Submission: Hunter Transmission Project - SSI-70610456

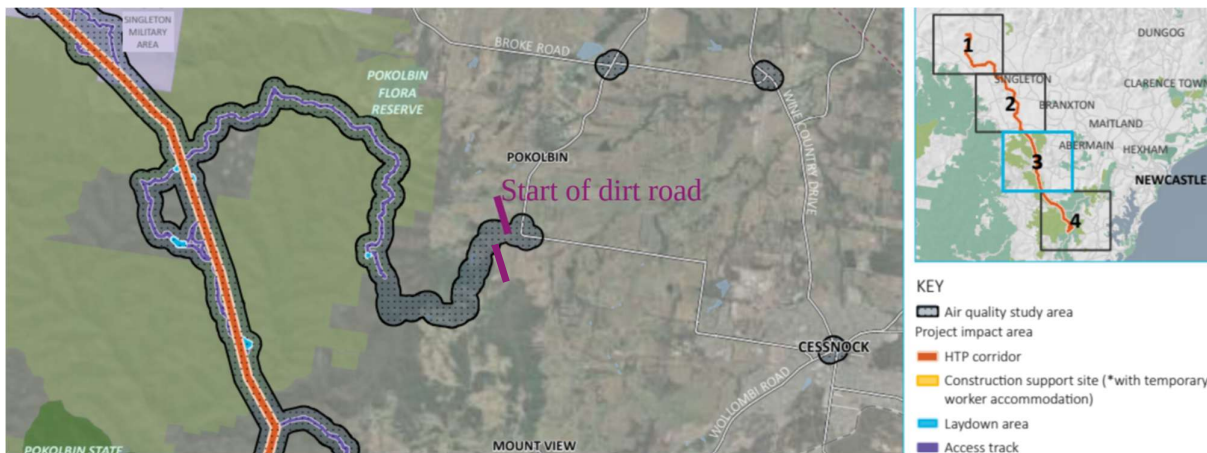
However, it is not clear that the assessment adequately considers the dust generation of vehicular movements along unsealed (dirt) access tracks, including Pokolbin Mountains Road.

The assessment does not adequately consider dust-related impacts for the following:

- The air quality study area (Figure 3.4) includes the Pokolbin Mountains Road. However, none of the businesses, vineyards, residences (including roof drinking water sources), livestock drinking water sources (including Foxy Gully, Muggyrang Creek and farm dams) or public recreational use areas (such as the Great North Walk) were mapped or considered within the assessment. The receptors assessment conducted is therefore insufficient.

- The impact and use of the unpaved Pokolbin Mountains Road, from the transition of the asphalt wearing course to the start of the dirt road (refer figure below). Heavy vehicle movements will use this access route (no actual numbers have been provided for Pokolbin Mountains Road in the EIS). There are no alternative access routes once vehicles turn off McDonalds Road onto Pokolbin Mountains Road. Therefore the impacts to receptors start at the beginning of the dirt road and have not been assessed. The AQGHGIA states:

Figure 5.10 Proposed passing bays on Pokolbin Mountains Road

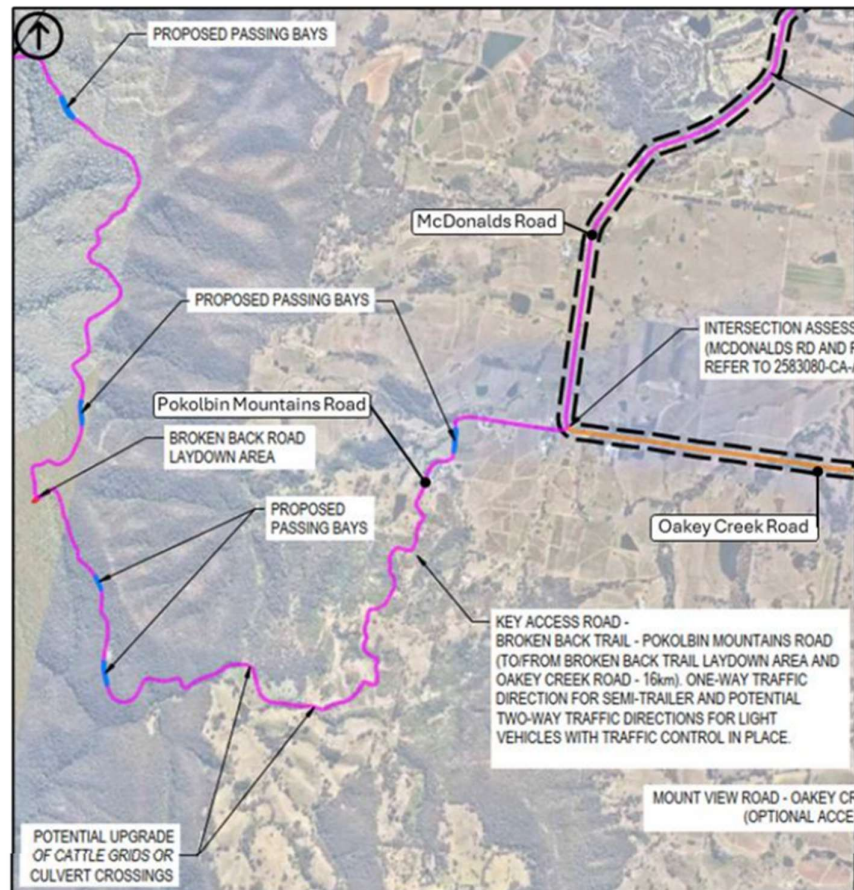
The TTIA describes Pokolbin Mountains Road as a bidirectional, unsealed likely 60 km/hr road. Pokolbin Mountains Road is single lane in some sections (there is signage) and typically unsafe to travel more than 40 km/hr along the majority of the road. Two way traffic directions for light vehicles are proposed (refer to figure below) with proposed passing bays and one way for heavy vehicles.

For unsealed roads, including within State forests, light and heavy vehicle movements have the potential to impact road condition, including during wet weather or prolonged dry weather periods. Pokolbin Mountains Road is maintained by Cessnock City Council periodically, including the recent geotechnical and grading works completed by council in relation to a land slip occurring at approximately half way along its length. However, the condition of Pokolbin Mountains Road has varied and readily deteriorates due to a lack of drainage controls and wet weather. The road condition is strongly influenced by runoff from the roadside escarpments and the upper catchment,

with limited to no culverts or drains present. As a result, the road regularly washes out making access treacherous for light vehicles. As part of post approval commitments:

- EnergyCo should commit to dilapidation surveys (including geotechnical survey) of Pokolbin Mountains Road and supporting rock to ensure public safety will not be compromised during and after the construction phase as a result of heavy vehicle movements.
- EnergyCo should commit to installation of permanent drainage controls (including culverts) for Pokolbin Mountains Road to be maintained for the construction phase and passed over to Cessnock City Council for maintenance following completion of construction.
